STB Finance Docket No. 33407
Surface Transportation Board

Comments on PRB Expansion DEIS

Re: Comments on PRB Expansion DEIS

RE: COMMENTS ON APPLICANT'S ALTERNATIVE ROUTES ANALYSIS

Figure 1. Ground and track profile of DM&E's Alternative C between Smithwick and Wasta

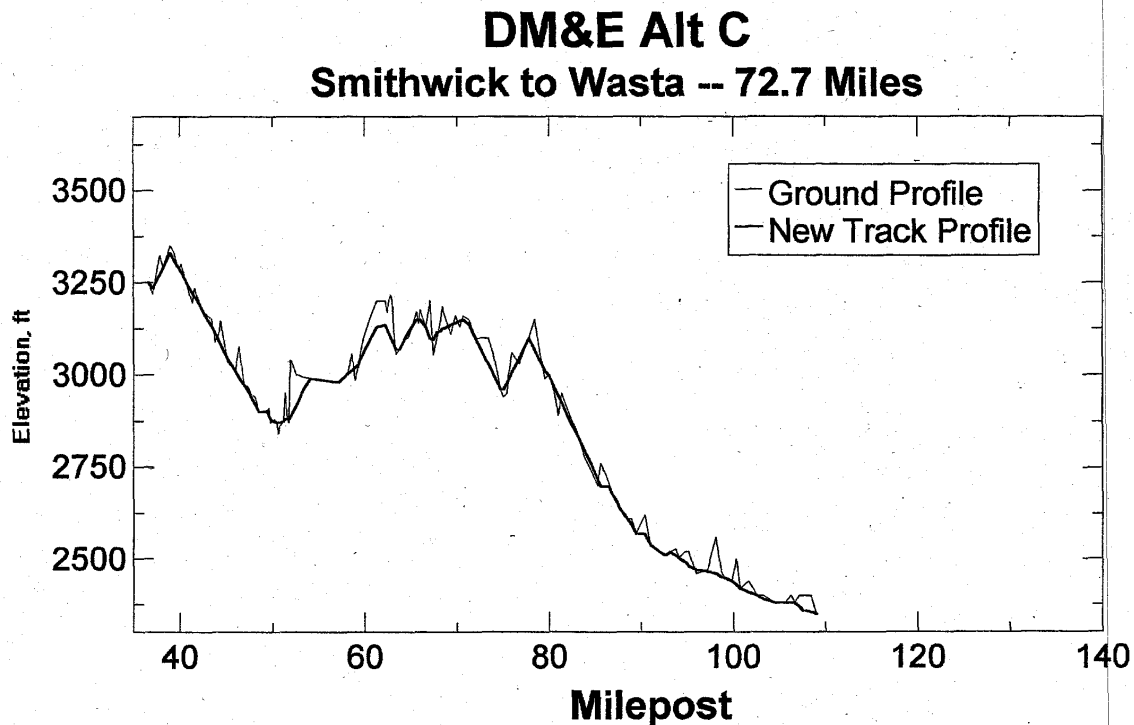
2). In addition, these Cheyenne River "pinch point" earthworks (see Figure 1 from mileposts 90 to 109) are only a small part (19.7%) of the earthwork volumes that will be needed to meet grade and curvature constraints along the Alternative C alignment. Most of these excess earthworks are needed to climb out of the Cheyenne River drainage, cross the French Creek and Battle Creek drainages, and drop down into the Spring Creek drainage

(see Figure 1 between mileposts 50 to 80). These earthwork estimates are also likely to be underestimated, since they do not consider the unstable soils along this alignment, but rather use the same width-of-cut factor as the rebuilt D6 alternatives. Only engineering design evaluations would provide the cross-fall, cut slope, cut-and-fill balancing, and other important information necessary for an accurate earthworks quantity estimate, but all of these factors are likely to result in greater relative increases in grading quantities along the Alternative C alignment than along the more-stable existing corridor alignments.

Figure 2. Existing ground and track profile of rebuilt Alternative D6a (Inner Bypass)

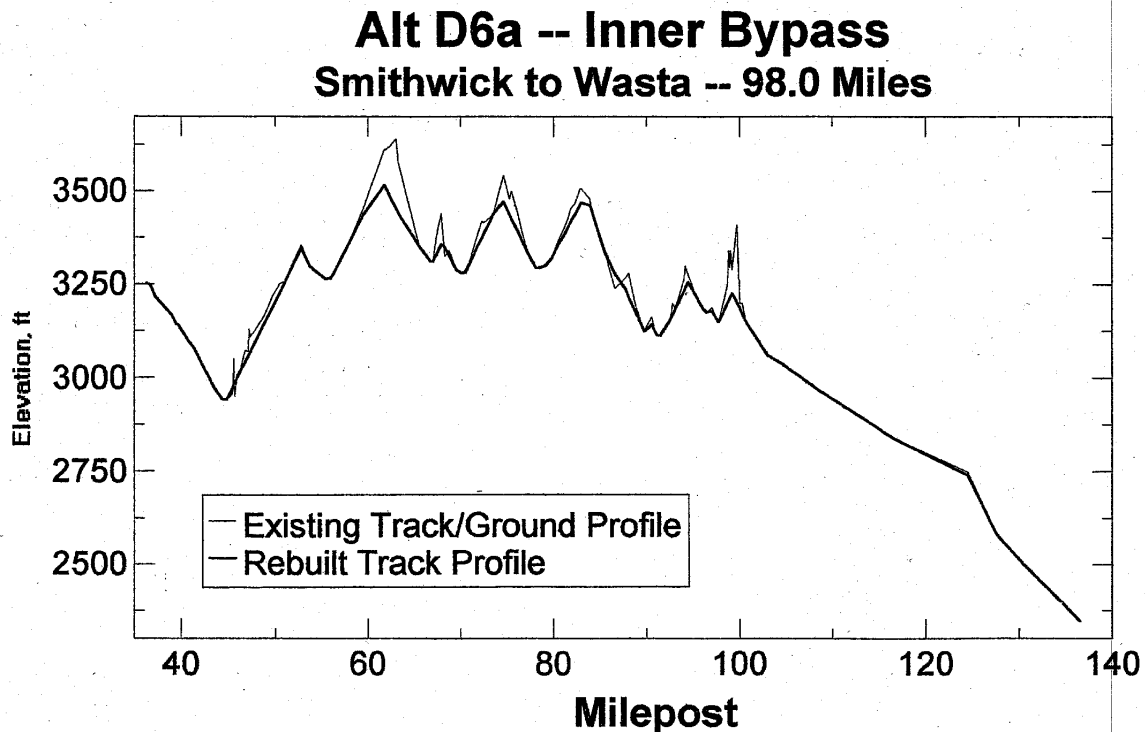
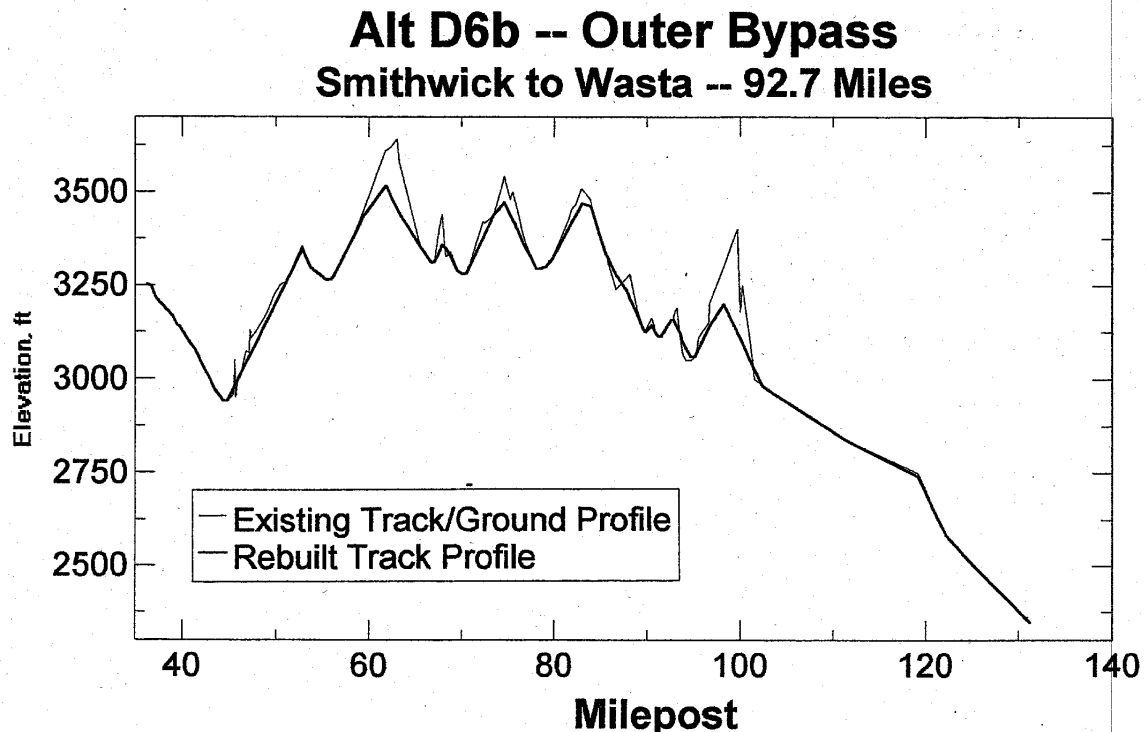
crossing St. Patrick Street, joining the existing track at westbound milepost 644.8; and an "Outer Bypass" (Alternative D6b) which leaves the existing route at northbound milepost 92.6 and heads northeast, passing north of the Rapid City Regional Airport, and joining the existing track at westbound milepost 637.9. The Inner Bypass shortened the existing route by an additional 3.5 miles, while the Outer Bypass shortened the existing route by an additional 8.8 miles, resulting in rebuilt lengths of 98.0 and 92.7 miles, respectively. Both bypasses resulted in significant earthworks to cut through the ridge between the Rapid Creek and Box Elder Creek drainages, as shown in Figures 2 and 3, comprising 18% and 35% of total "cut volume" earthworks, respectively. The magnitude of the earthworks increases significantly the further east the ridge crossing occurs, as can be seen by comparing Figure 3 to Figure 2.

Analysis. The following observations can be made about the values in Table 1, the as-built track profiles shown in Figures 1-3, and the information provided in the Applicant's Comments (the numbers in parentheses in Table 1 give parameter index values relative to Alternative C):

Figure 1. Alternative Routes for Climbing the "Wall Hill", Wasta to Wall, SD.

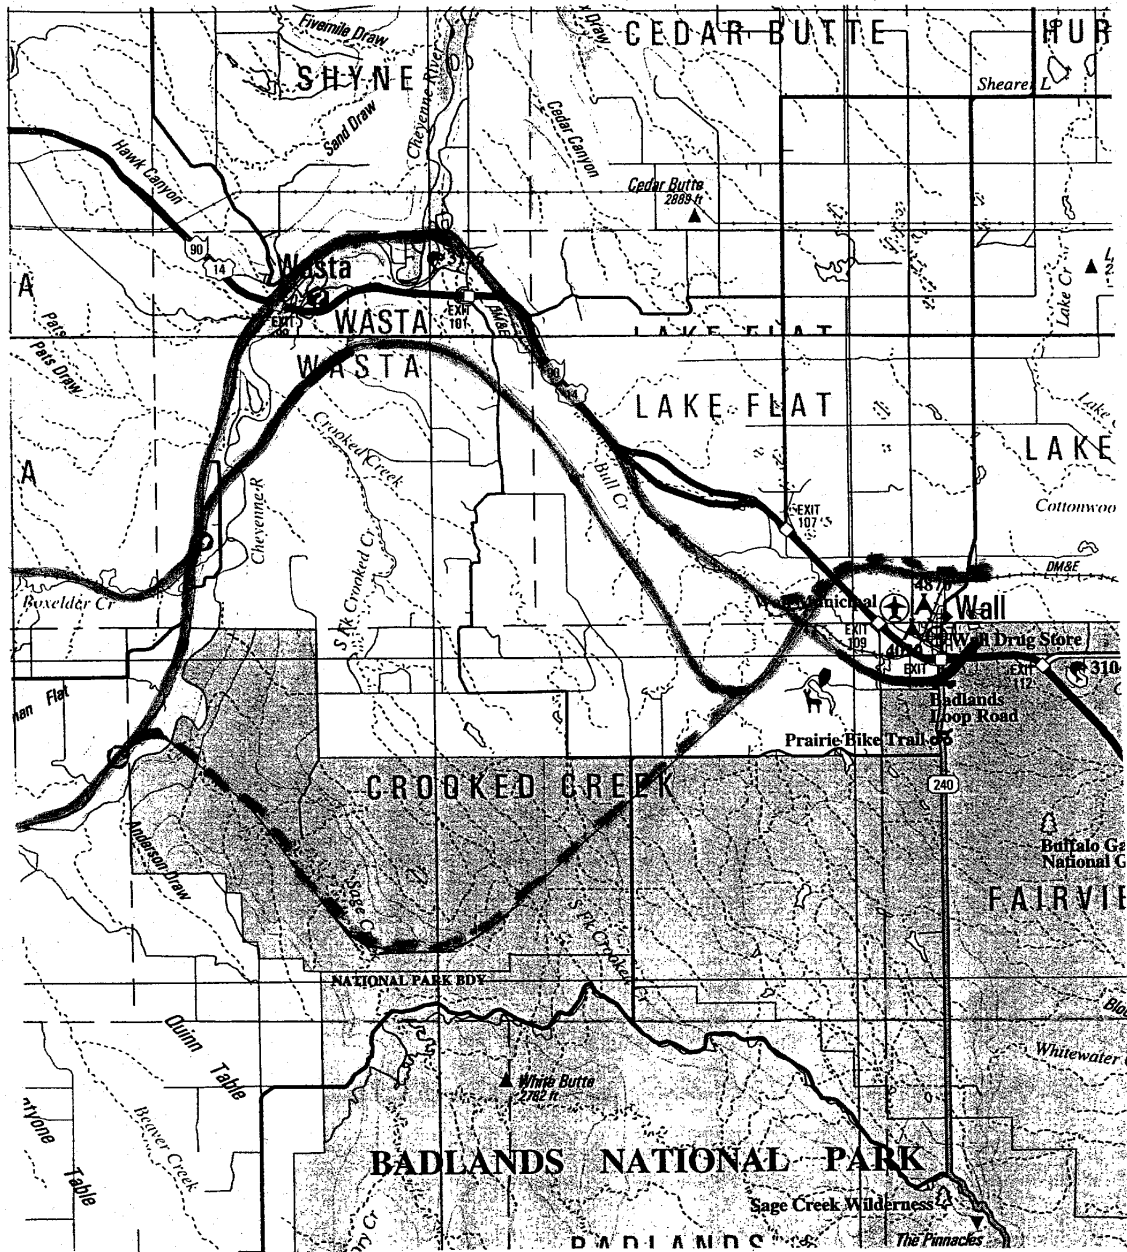
DM&E's proposed Alternative C is shown in red. The rebuild Alternative D6S which follows along the Bull Creek alignment is shown in blue. The rebuild Alternative D6W shown in dashed-blue joins the Alt C alignment after it crosses Bull Creek. The Sage Creek Alternative C1 is shown in dashed red from the Cheyenne River until it joins the Alt C alignment at its southern "recurve" point.

The earthworks calculations show that both rebuilds of this section from Wasta to Wall (with a bypass either to the west or south of Wall) can meet the geometric constraints of 1% maximum grades and 1 degree maximum curvature at reasonable cost, i.e., with less earthworks than for DM&E's proposed Alternative C. Once again, the rebuild options on the existing route are in fact reasonable alternatives under the terms of the National Environmental Policy Act (NEPA) and must be analyzed at the same level of detail as all other NEPA alternatives in the Environmental Impact Statement.

Figure 2. Ground and Track Profiles of the "Wall Hill" Alternatives

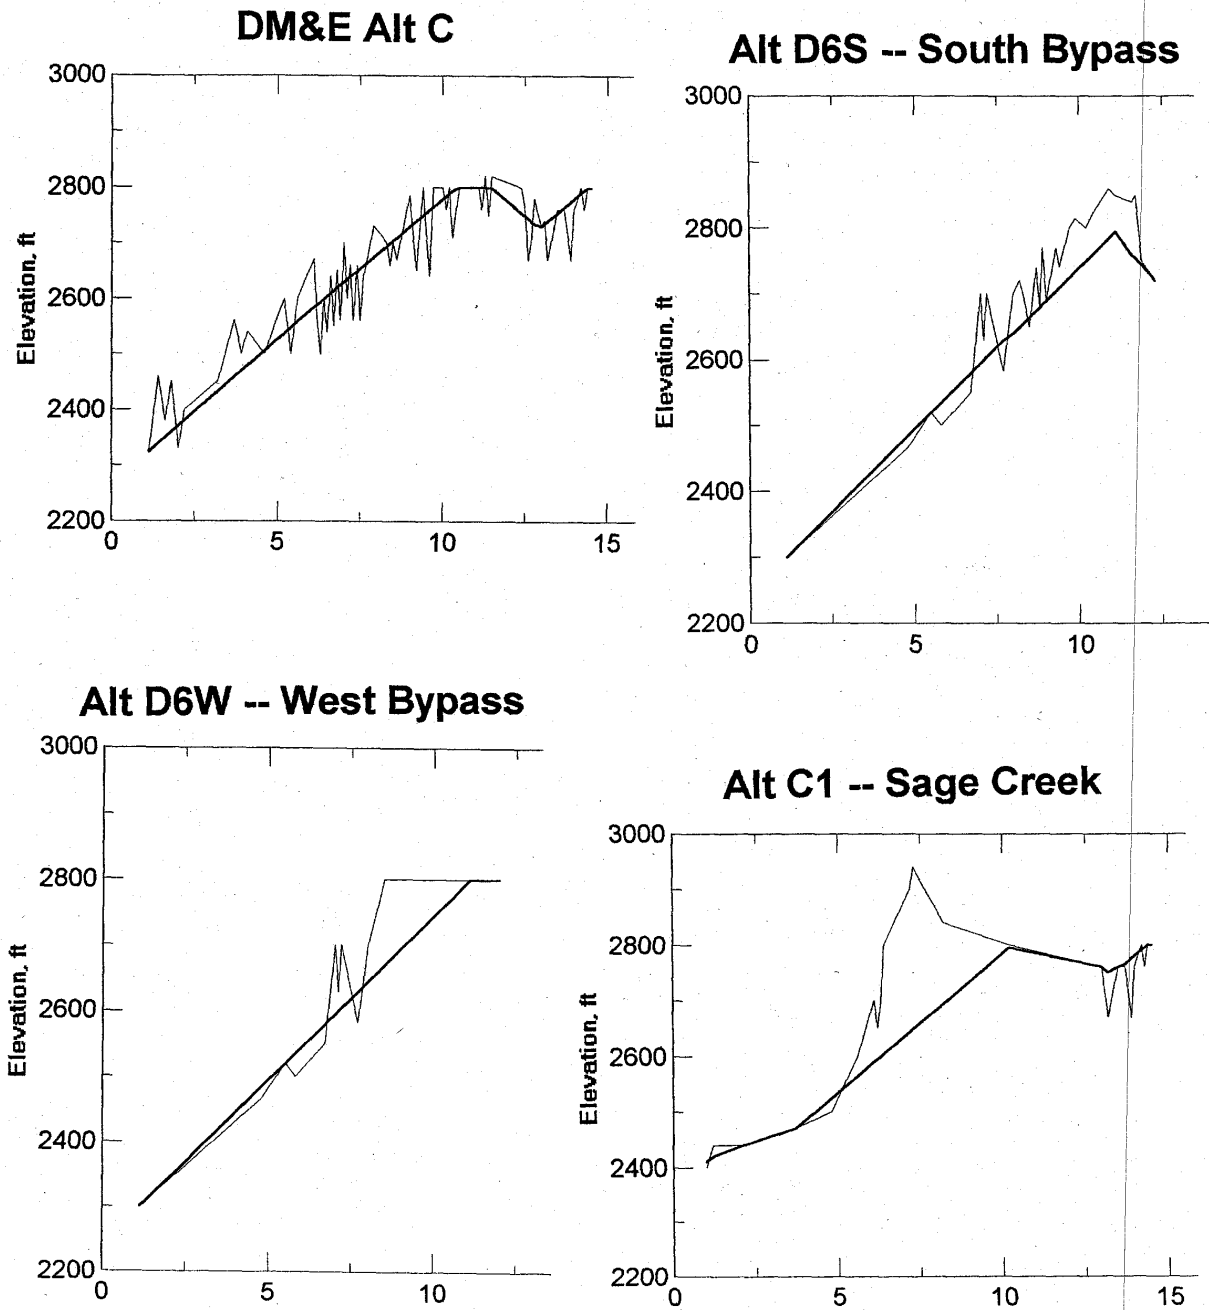
Analysis. The following observations can be made about the values in Table 1, the as-built track profiles shown in Figure 2, and the information provided in the Applicant's Comments.

1). The first observation to make is that the grading earthworks estimate for Alternative C is likely to be significantly underestimated, since this alignment parallels the contour lines along much of the climb out of the Cheyenne River Valley, meaning that it crosses all of the minor drainages and tributaries feeding Bull Creek from the south. This results in cross-slopes of 50-100% and more. In addition, these Pierre shale hills are extremely unstable, further complicating any large-scale construction that does not follow perpendicular to the contours. Most observers would probably suggest something in the range of 200-300% of normal as a reasonable earthworks cost estimate along this portion of the Alternative C route, meaning that the DM&E preferred Alternative C might have by far the highest earthworks quantities of any of the four alignments analyzed, even greater than the Sage Creek Alternative (C1).

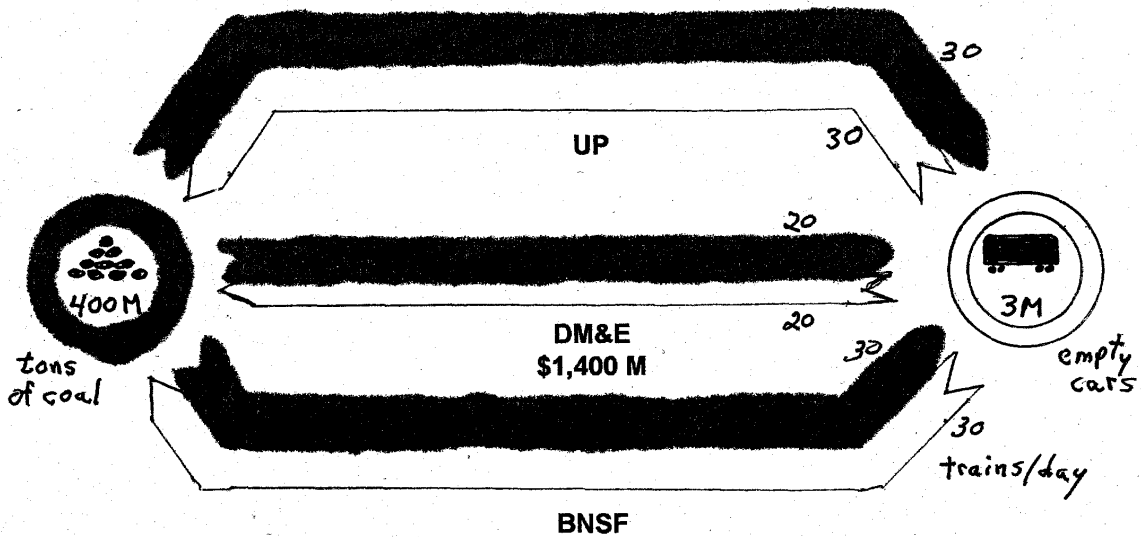
In order to investigate further why this application appears to be so nonsensical to so many people, let us look directly at the scenario that DM&E is suggesting will occur. I have tried to capture the essential transportation aspects in Figure 1 below, which shows in very rough schematic terms an annual demand to transport 400 million tons of coal from the Powder River Basin to midwestern utilities. At present, roughly 300 million tons per year is transported by the existing railroad facilities of BNSF and UP by roughly 120 trains per day, loaded plus unloaded. The Applicant proposes construction and reconstruction of a new heavy-haul rail line to carry an additional 100 million tons per year (or roughly a one-third expansion of capacity), on roughly 40 trains per day, loaded plus unloaded, at a preliminary construction cost of around \$1,400 million [STB 12/10/98 Transportation Decision at 40-41]. The Applicant presents no countermeasures that would be taken by BNSF or UP to protect their existing market shares.

This is an extremely unlikely scenario from a transportation standpoint, since the major factor affecting capacity of a unit-train system is the transportation "effectiveness" of the backhaul portion. The Applicant presumes that three firms will continue to operate two-way flow systems, with each empty train consuming capacity that could be used for additional loaded traffic. [Loaded train flows are shown by the dark arrows and empty train flows by the light arrows in Figure 1.] If empty backhauls could be moved to other tracks, the coal hauling capacity of the transport system would be effectively doubled.

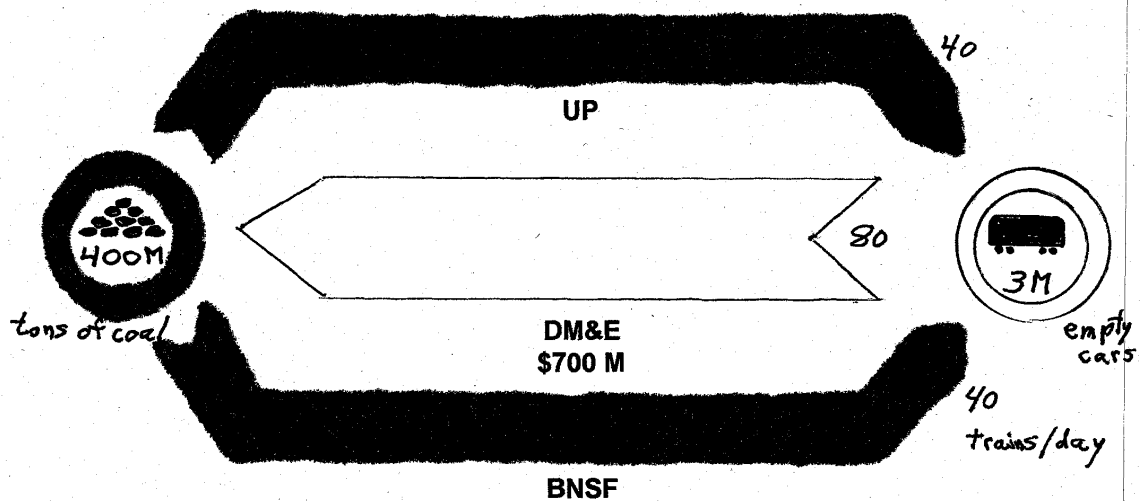
This is much more likely to occur than the scenario proposed by the Applicant, and is shown schematically in Figure 2 below.

For comparison purposes, Figure 2 retains an overall transport demand of 400 million tons per year of PRB coal, but focuses on the equally important usage of the 3 million empty coal cars per year that are "produced" at the midwestern utilities by the process of transporting this coal. From a transportation standpoint, the "capacity" of BNSF and UP facilities can be doubled by having the empty coal cars and locomotives returned to the PRB by a one-directional flow over the Applicant's new rail line. All of the loaded trains would flow eastward over BNSF or UP mainlines, and all of the empty trains would return westward over the Applicant's new (light-rail) line. The total flows on BNSF and UP would be reduced from a total of 120 trains per day (loaded plus unloaded) to 80 trains per day (loaded only). The Applicant's projected flows would double from 40 trains per day (loaded plus unloaded) to 80 trains per day (unloaded only).

This second scenario is much more likely from a transportation standpoint, for the following reasons. First, the capacity of BNSF and UP could be increased by 50% and still meet the congestion levels experienced by the current mixed-flow regime, effectively raising PRB coal capacity to 600 million tons per year, without any additional investments by BNSF or UP. Second, the construction costs could be considerably reduced, since only a light-rail system would be needed (loaded coal cars weigh ten times or more than empty cars weigh). Thus, engineering constraints could also be relaxed, easily to 2 percent grades and 2 degrees of curvature, thereby eliminating many of the environmental impacts from the construction and reconstruction activities. Applicant's engineering objections to using the existing corridors between Wall and Smithwick would disappear, as would the construction problem on the "Wall Hill". A bypass a Pierre might also become feasible under these relaxed engineering constraints.
